## PLANNING JUSTIFICATION REPORT – ADDENDUM NO. 1

### Proposed Official Plan Amendment and Zoning By-law Amendment OZ / OPA 25-8 W2

900 Lakeshore Road West  
City of Mississauga, Ontario

**Date:** March 20, 2026

Figure 03 —Location of Zoning By-law Required Outdoor At-Grade Amenity Space

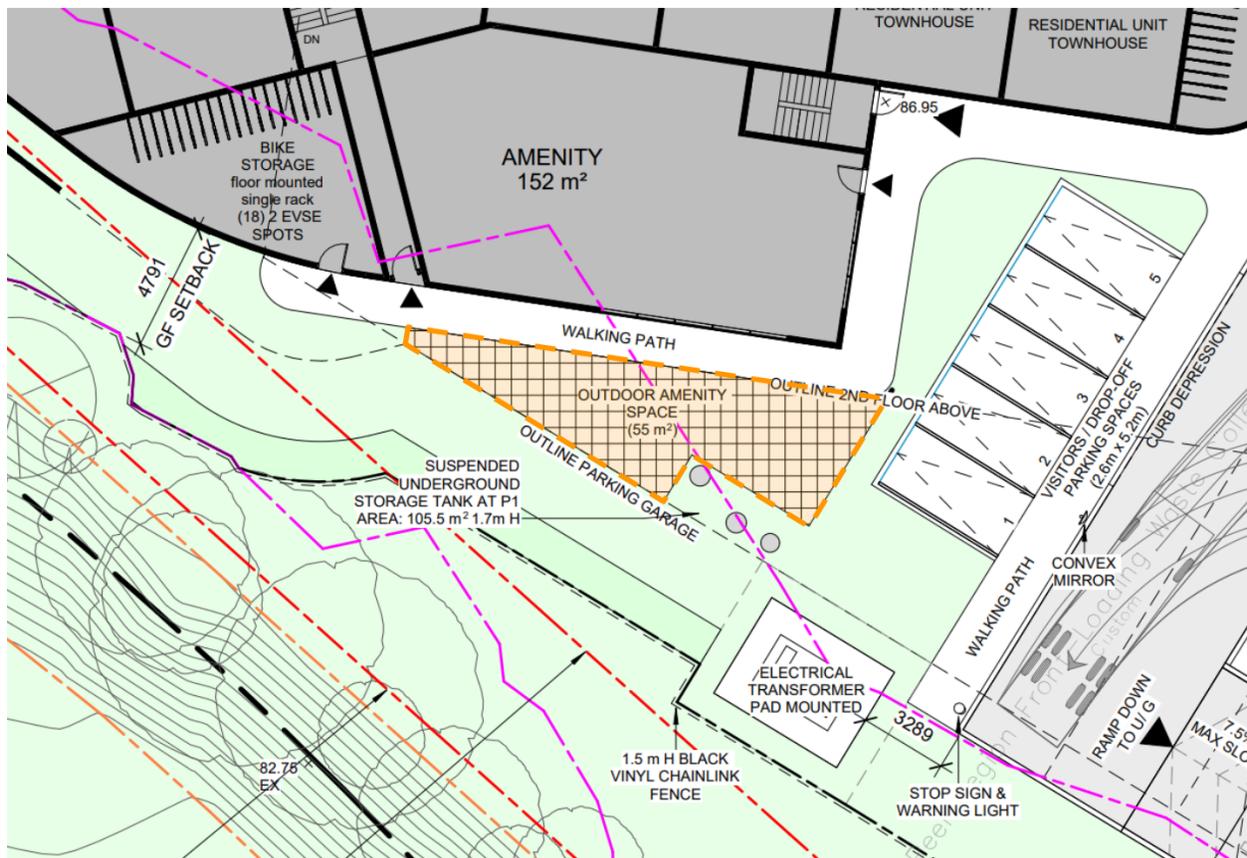
A Sun/Shadow Study was submitted as part of the initial OPA & ZBA application. The Mississauga Urban Design Department states that this study is required to assess the shadow impacts on the proposed outdoor amenity areas at-grade within the development site. In addition, the City of Mississauga's Community Services, Landscape Architect requested that the site plan identify the size and location of the proposed outdoor amenity spaces, which are to be incorporated into the updated Sun/Shadow Study. Lastly, it was expressed that the Richard's Memorial Park was not to be assessed under the criteria for Communal Outdoor Amenity Areas despite the presence of a playground, picnic area, public beach, and public garden. In response to this comment, please consider the previous assessment of these locations in these areas for shadow impacts to be retracted. Adjacent parkland was assessed within the previous Sun/Shadow Study and no comments were made regarding the findings - being a total Sun Access Factor of 98%. The architectural drawing set submitted alongside this letter identifies the location and area of all ground level outdoor amenity spaces, and the following assessment of those spaces is provided in alignment with the City of Mississauga Standards for Shadow Study criteria.

The impact being assessed is the shadowing onto the shared outdoor amenity space provided along the southern extent of the proposed building (see Figure 03 above). This area

is the Zoning By-law required amount of outdoor amenity space to be provided at-grade (55 square metres). The impact is assessed on each of the test dates (June 21, September 21, and December 21) and the criterion is met if the “sun access factor” is at least 50% or 0.5 on every date (As(ave) /AT = 0.5 or more). Table B below provides the sun access calculations for this criterion.

As demonstrated in the above assessment, the shadow impacts on the proposed outdoor amenity areas within the development site are minimal and fall within the prescribed tolerances of the Standards for Shadow Studies criteria for the September and December dates. The location only fails by 5% on the June date. Due to the excellent performance on the other dates we believe this non-conformance to be very minor and should not prevent the staff recommendation of the proposed application.

Figure 04 — Grade-related Wind Impact Mitigation Measures

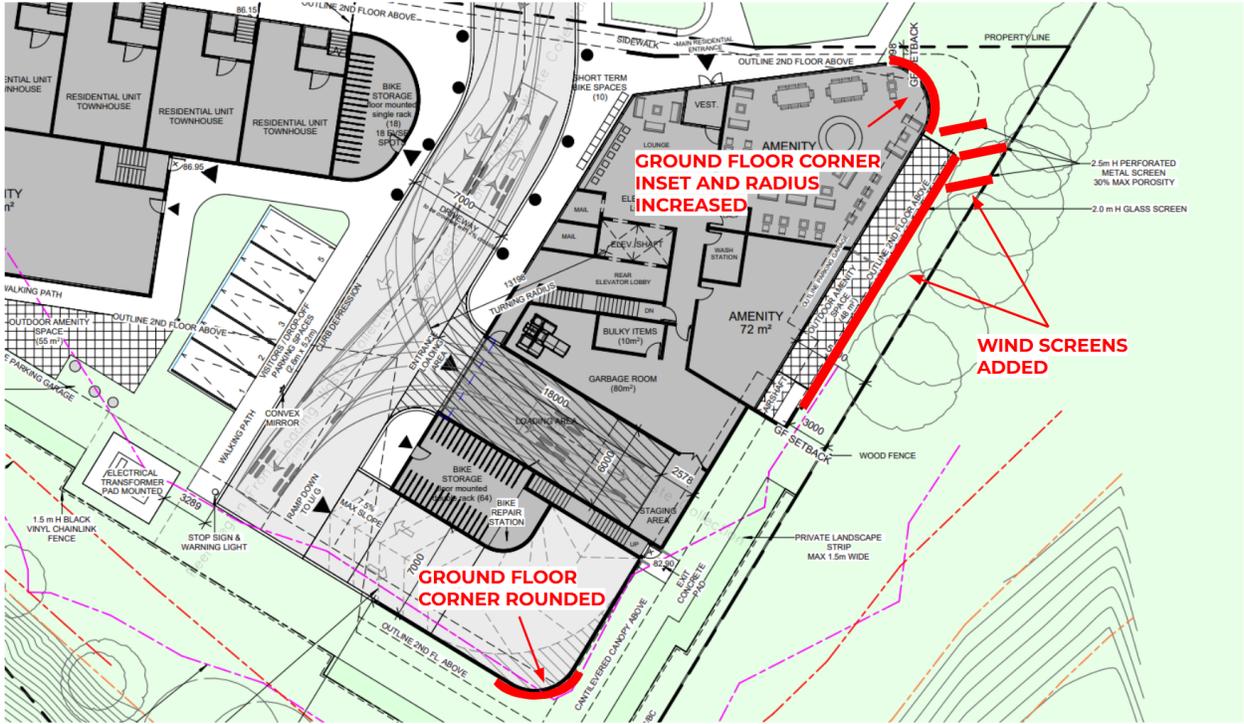
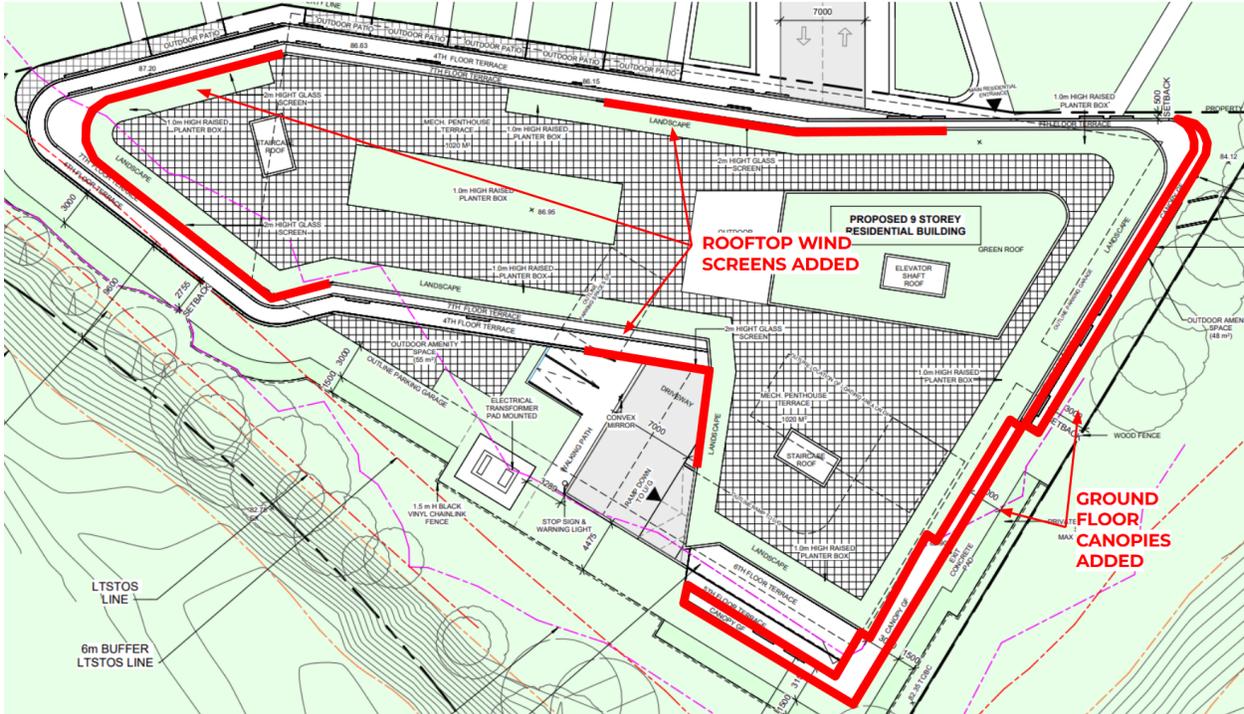
Initial concerns over harsh wind impacts from the proposal's built form were raised by Mississauga's Community Services Landscape Architect, Planning and Community Services staff, and the City's Urban Design Department. These concerns followed their review of the original Pedestrian Wind Environment Statement (Qualitative - January 31, 2024) and the Pedestrian Wind Environment Study (Quantitative - October 19, 2024) prepared by Windtech as part of the initial OPA/ZBA application submission. This report indicated unusually high wind conditions at certain pedestrian accessible areas at-grade. Members of the LPEA raised similar concerns during the Planning and Development Committee meeting on July 28, 2025. Following receipt of staff comments from the initial submission, It was confirmed by Windtech Consultants that the initial study contained a miscalculation that had overstated wind impacts due to a ratio-swap error leading to inflated wind speed outputs. Once corrected, the predicted wind speeds were reduced.

Even still, above average wind readings were present on site. In response, the proposal and subsequent wind report, included as part of this submission, have been adjusted, including a revised building height from ten to nine storeys and several additional wind mitigation measures such as the utilization of a canopy along the east elevation at-grade, and metal wind screens, located in front of the northeast corner of the building, (see Figures 04 & 05), Both features have been positioned to help reduce wind gusts coming from the east. The revised Wind Tunnel Study, dated February 25, 2026 and completed by Windtech, shows that proposed measures have been effective. In the initial study, thirteen sensors did not meet safety criteria. Now, there are currently no areas of safety concern remaining, in accordance with the City of Mississauga's terms of reference for the Pedestrian Wind Comfort and Safety Study, (see Figure 06). Therefore, according to the revised Wind Tunnel Study conducted by Windtech consultants, the applied aforementioned measures have been successful in reducing wind impacts on site. There are still two sensor locations that fail comfort criteria toward the northeast corner of the site. It is our understanding that comfort standards can be addressed with landscaping, and it is our intention to explore reducing these areas of impact further through landscaping and public realm design during the Site Plan Approval phase.

Figure 06 — Wind Tunnel Results of the Proposed Annual Scenario – Ground Level Plan

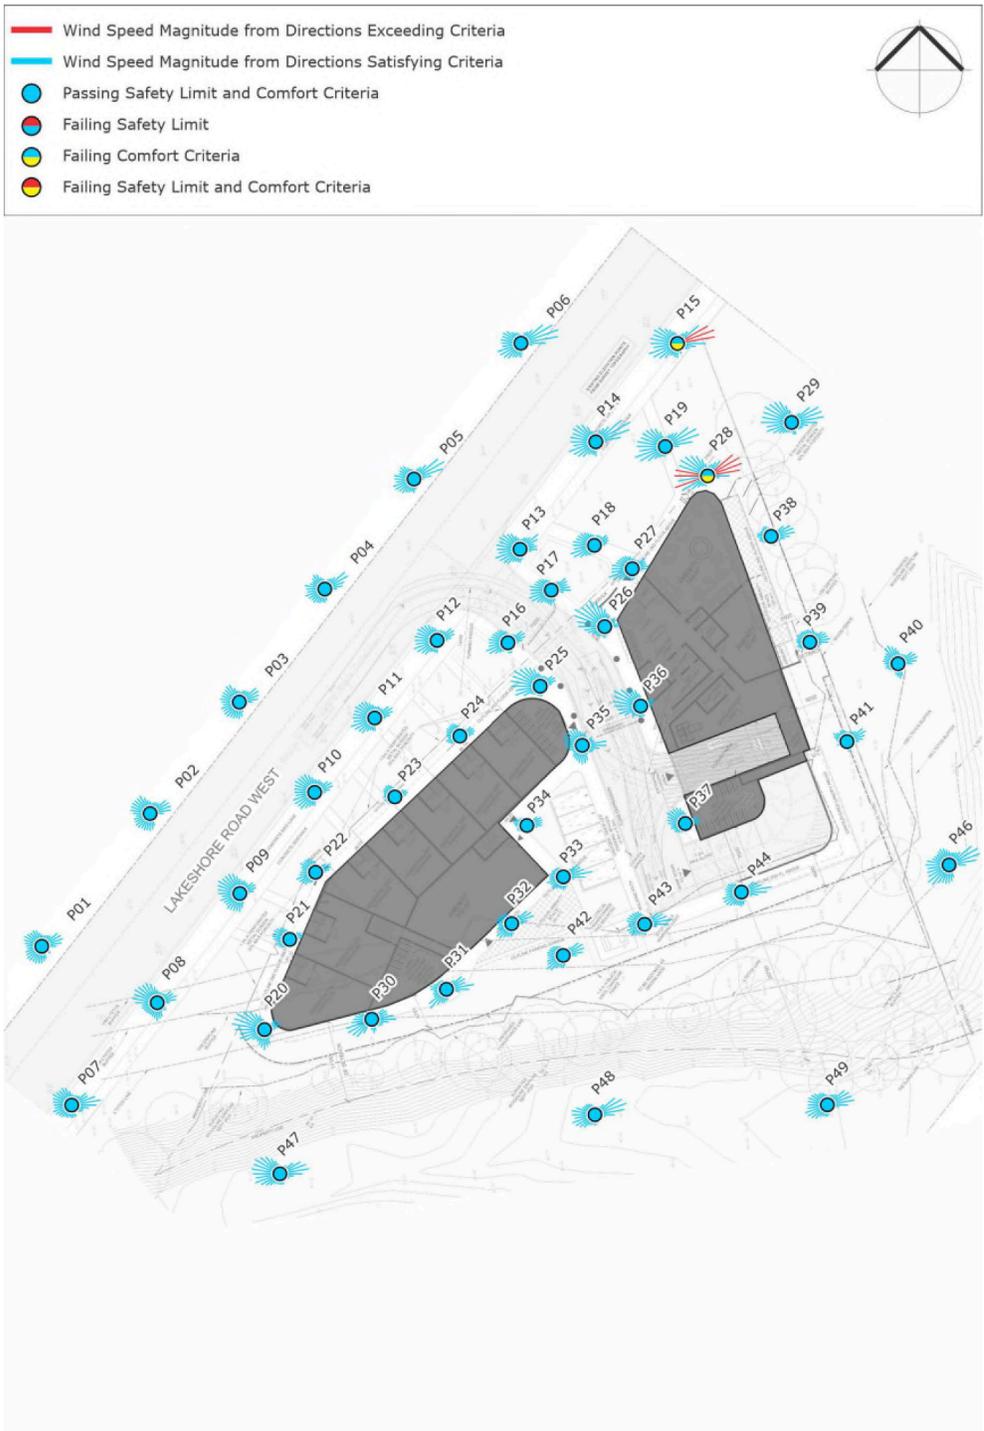
Development Planning, Urban Design and Community Services departments, along with the Lorne Park Estates Association raised concerns regarding potential wind impacts on the surrounding natural environment and mature trees adjacent to the site. Urban Design staff requested that testing sensors be placed beyond the site, within the natural heritage features, to assess wind impacts on the surrounding environment, particularly on existing vegetation. Windtech notes that assessing impacts on vegetation is beyond the scope of a Wind Assessment, as the purpose of a Wind Comfort Study is to evaluate effects on residents and pedestrians at-grade, rather than on natural features. However, additional sensors were implemented in the revised wind tunnel testing beyond the property lines to the east and south of the site within wooded areas. These sensors returned wind readings that fell below the maximum permitted windspeeds, thereby meeting the safety requirements and comfort criteria of Mississauga's terms of reference (see Figure 06). The following statement has been provided by Windtech with respect to the results of these sensors:

*"Wind conditions in the existing tree area (approximately represented by sensor locations P40, P46, P47, P48, and P49 – see image below) in the "Proposed" test configuration are as expected in close proximity to a development of this type in this area of Mississauga, particularly given its general exposure to strong winds blowing in from Lake Ontario. These existing trees would be subjected to the strongest winds in the winter. During that time, when compared with existing wind conditions, the presence of the proposed development is in fact anticipated to improve wind conditions at locations P40, P46, and P49... and would only slightly increase wind speeds at locations P47 and P48... Where an increase is predicted, wind speeds in these areas are unlikely to result in sufficient uplift pressures that would uproot these trees. It should be noted that in the summer, wind conditions in these areas would likely be calmer than those presented in the report, as testing was conducted without landscaping, as per the City of Mississauga's Urban Design Terms of Reference: Pedestrian Wind Comfort and Safety Studies as well as to provide worst-case, baseline wind conditions."*

Figure 07 — Detail of Site Servicing Plan prepared by Lithos Group Inc.

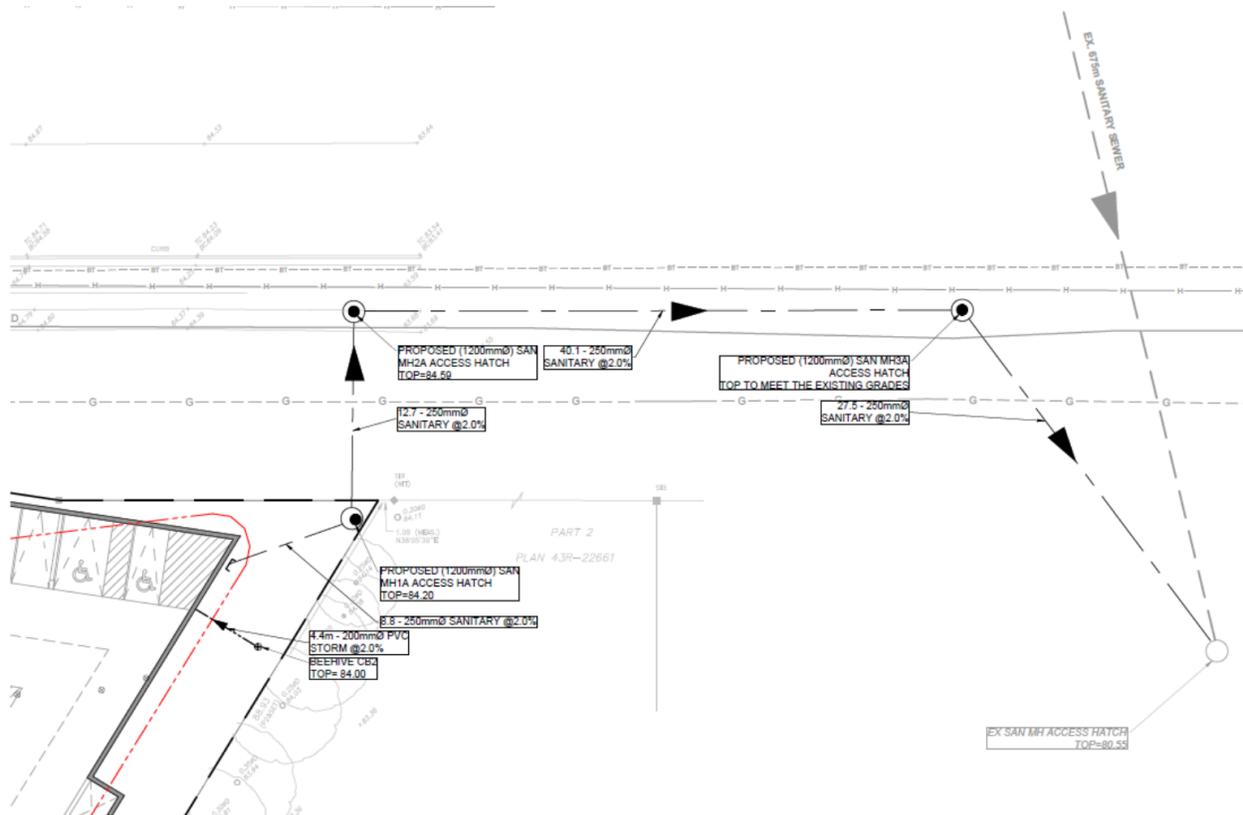
Following the review of the initial submission, Peel Region confirmed that the proposal will not be permitted to connect to the watermain and sanitary trunk sewer currently being constructed along Lakeshore Road West. In response, two alternative sanitary servicing alignments have been explored as potential solutions. These options were developed through coordinated discussions with Region of Peel and City staff. Lithos Group Inc. is the civil engineering consultant identifying an alternative servicing solution acceptable to both the Municipality and the Peel Region. Both solutions that were explored involve connecting to the existing downstream manhole of the 675 mm sanitary sewer, located within Memorial Park, just west of the pumping station and east of the subject property (see Figure 07). After multiple coordination meetings with City and Regional staff, it was determined that the wastewater connection option running along Lakeshore Road and the Regional right-of-way would be the preferred option of City staff, as it avoids encumbrances onto a public park, and represents a feasible and constructable wastewater servicing solution.

This option routes a sewer servicing connection from the subject lands east along Lakeshore Road West and then south into Memorial Park to reach the same existing manhole (see Figure 07). Because this route follows a busy arterial road, it will require coordination with the appropriate authorities to meet Municipal and Regional servicing requirements. Restoration needs along the roadway must follow standard Municipal and Regional requirements. Maintenance access would be available through manholes and activities such as inspection, flushing or repair may require traffic control or staged access along the road. According to Lithos Group Inc.'s research this option offers a viable solution for connecting the proposal to a sanitary servicing system.
